**From:** Daniel Turk <Daniel.Turk@turkslegal.com.au>  
**Sent:** Saturday, 16 March 2019 12:29 PM  
**To:** council  
**Subject:** DA (10.2018.466.1) 61 Kingsley St Byron Bay

**Re: DA No. 10.2018.466.1 (61 Kingsley Street, Byron bay):**

**RE: Submission in relation to Development Application No. 10.2018.466.1, Demolition of existing dwelling house and construct new dwelling house and swimming pool at Lot 11 Section 45 DP 758207, No. 61 Kingsley Street, Byron Bay.**

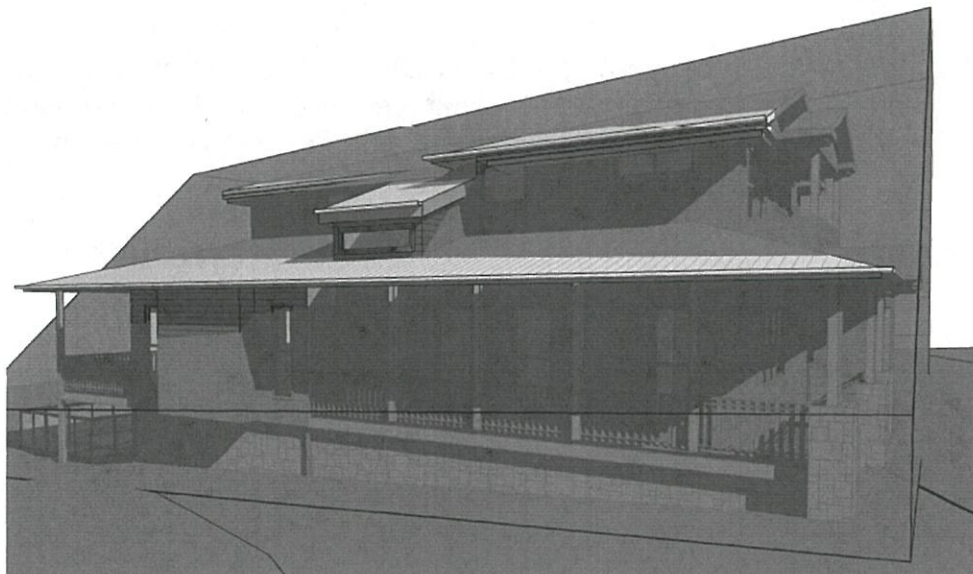
- significantly breaches the building height plain (vertically, but most materially on the horizontal western elevation overhanging our property, by up to an estimated 3-metres), &
- as a result, eliminates our access to winter sun on our eastern elevation (and into our main bedrooms and bathroom), &
- inflicts significantly breaches of our privacy

impacts significant overshadowing (eliminating our winter sun entirely on our eastern elevation - refer shadow diagrams below) and also inflicting devastating impacts on our privacy, as highlighted by my approximate interpretation of the height plane breach (refer image below):

3D View 3

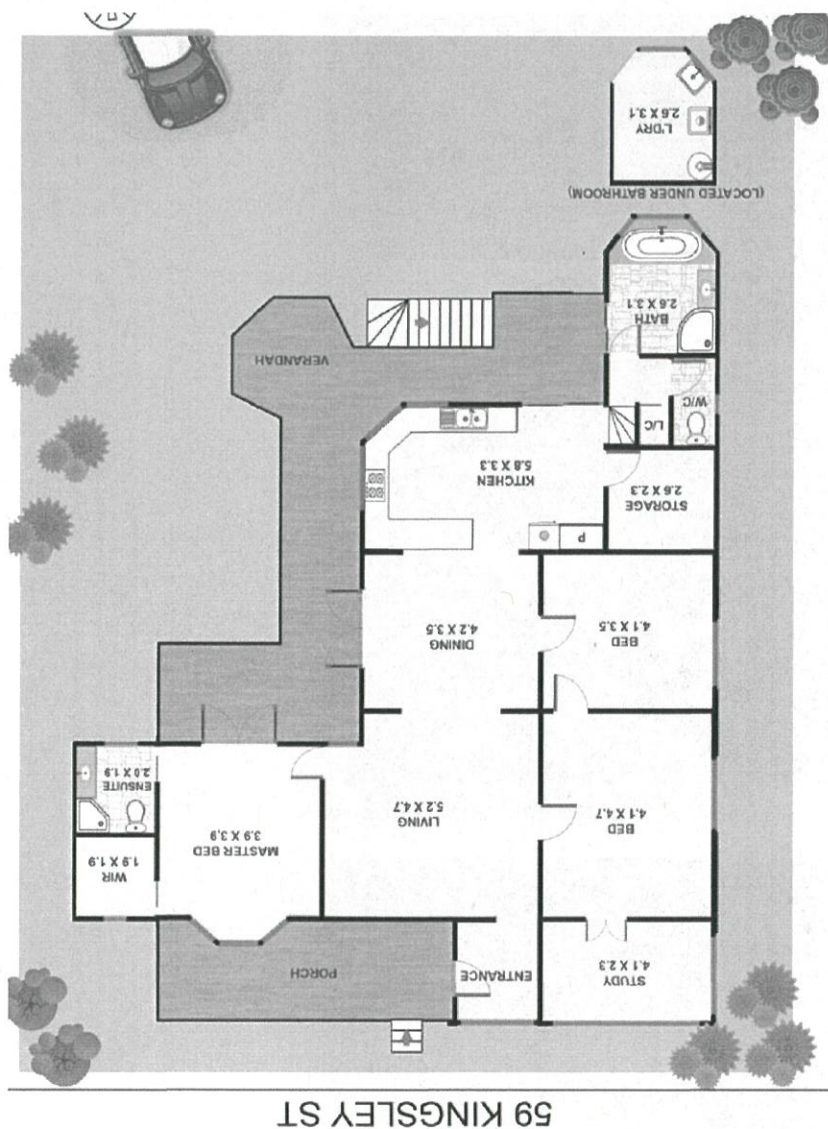
This continued height plane breach is supported by the 3D views provided in the amended plan (refer images below).

**Main Bathroom** (which will have rear entertainment deck built outside the high plane and looking directly into the main bathroom - with a birds eye view into the bath tub).

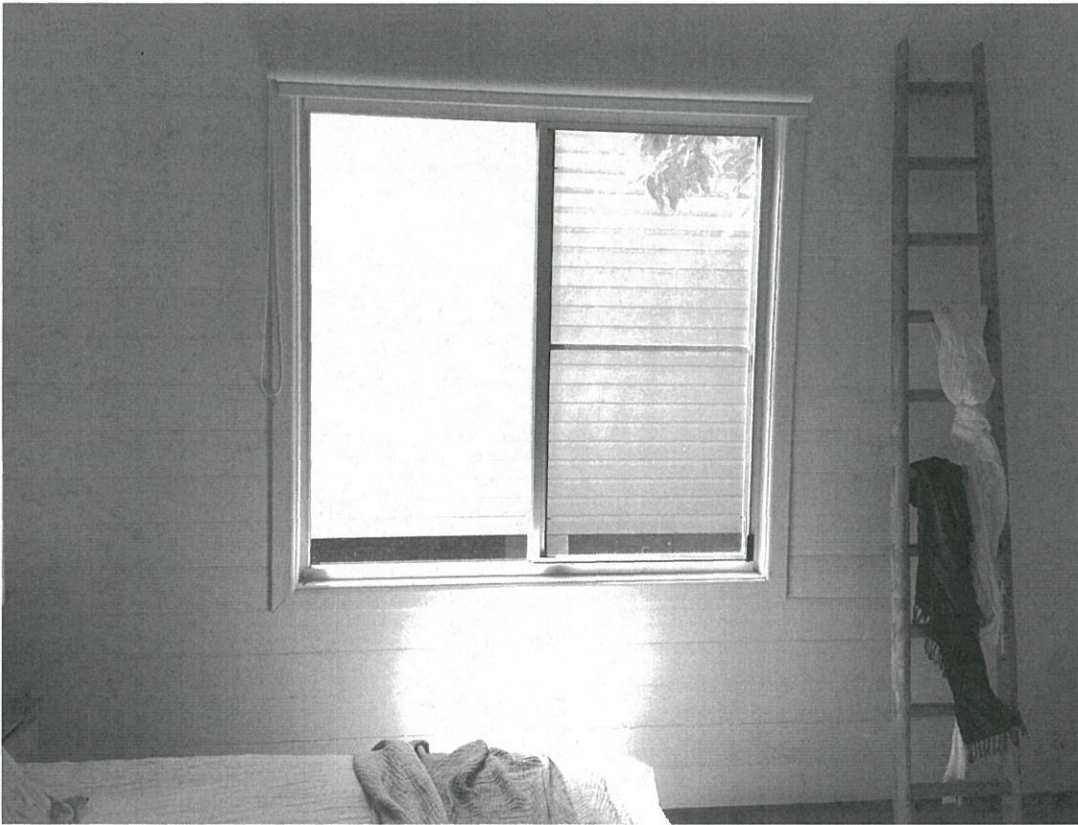
Also below are images of the private areas subject to the overshadowing and privacy breaches:

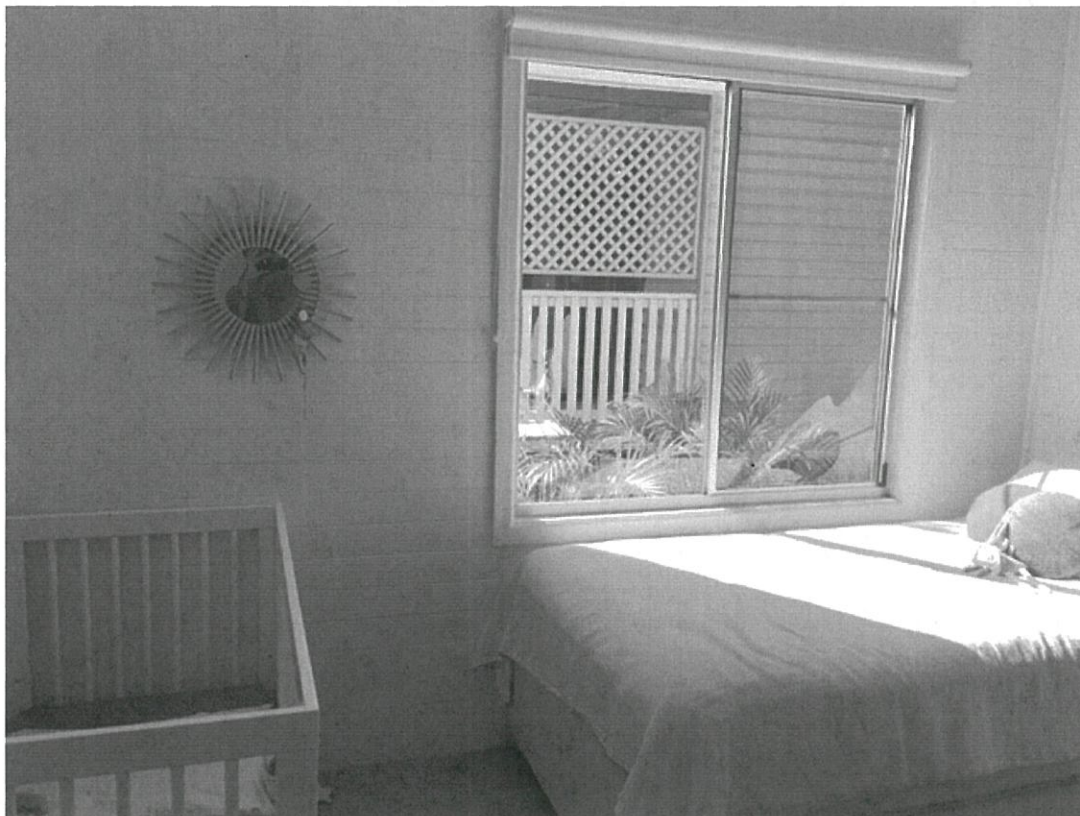
Plus our Baby's Bedroom (which will have the same large open verandah providing uninterrupted views into this private space):

## 59 KINGSLEY ST

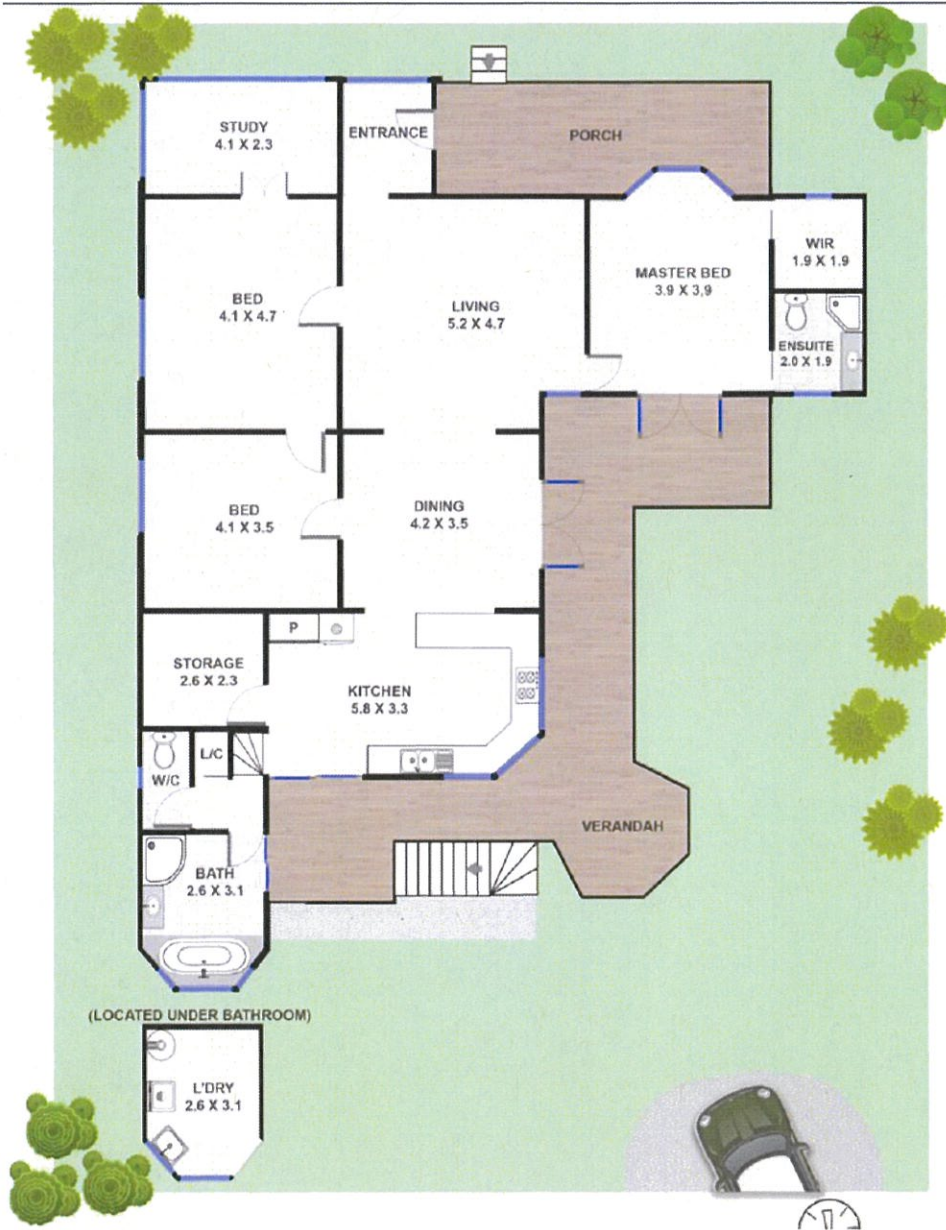
Further, the proposed large 2nd level entertainment deck (3.5M deep and across the rear of the entire building) will overlook the entire private backyard of our home, providing an open virtual viewing galley of (our main bathroom ), plus our entire backyard (and that of neighbouring properties):

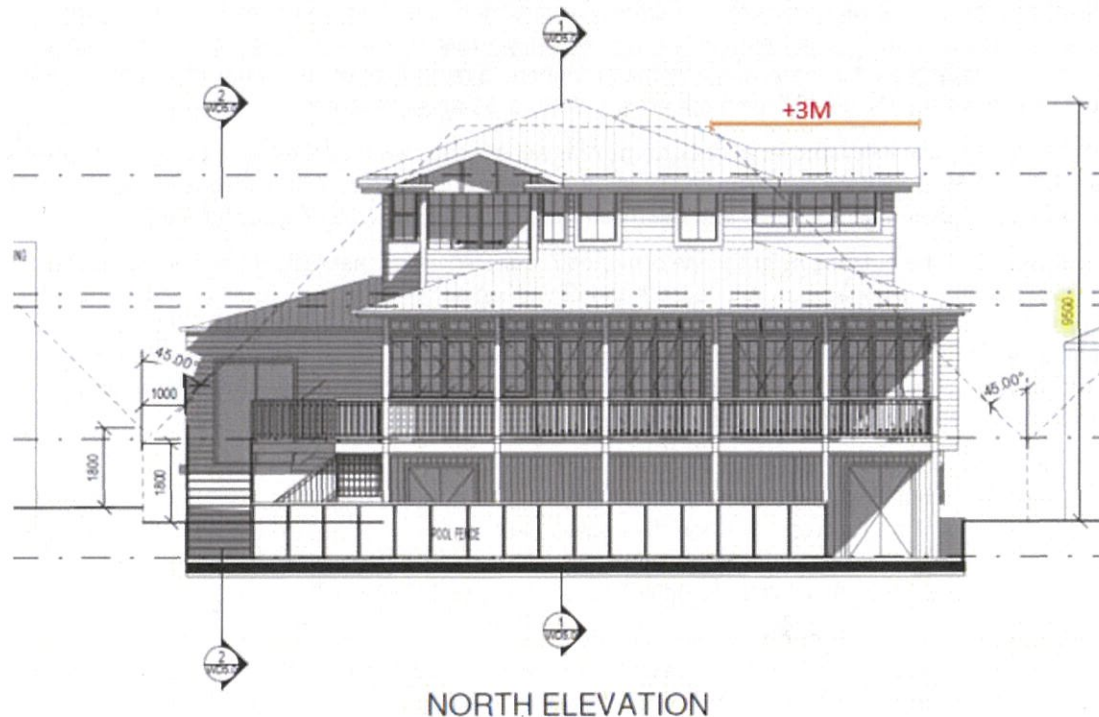
The plans submitted with the application indicate a significant breach to the building height plane on the western boundary adjoining our clients' property. The breach of the height plane as it applies to the western boundary extends along the full length of the proposed building and at the first floor level the building extends some 3 metres beyond the building envelope, as illustrated in the plan extract below.

This breach is not minor and will materially impact on the solar access and privacy of the adjoining property. The Statement of Environmental Effects submitted with the application states that the building steps in to minimise loss of solar access to adjoining properties and concludes that the breaches are inconsequential in relation to achieving solar access and maintaining privacy and views for the adjacent dwellings to the east and west. The Statement of Environmental Effects states that the proposal is consistent with the objectives set out in DCP2014.
